Access Compliance Report

Public Rights-of-Way

(Pedestrian Signals)

Intersection ID: N/A	Main Street:	Cross Street: N/A	Location: N/A
ADA ID: 831C7F42CBA2	Signal Type: One Push Button-Non APS	Overall Compliance: No	Severity Score: BTN 1: N/A BTN 2: N/A No BTN: N/A
Codes/Mitigation Info/Possible Solution		Field Measurements/Component Compliance

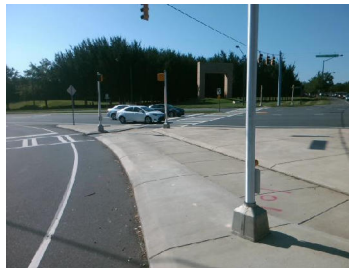
PROW/ADA: R404.7.1, R404.7.2

Possible Solutions: Provide Clear Space.
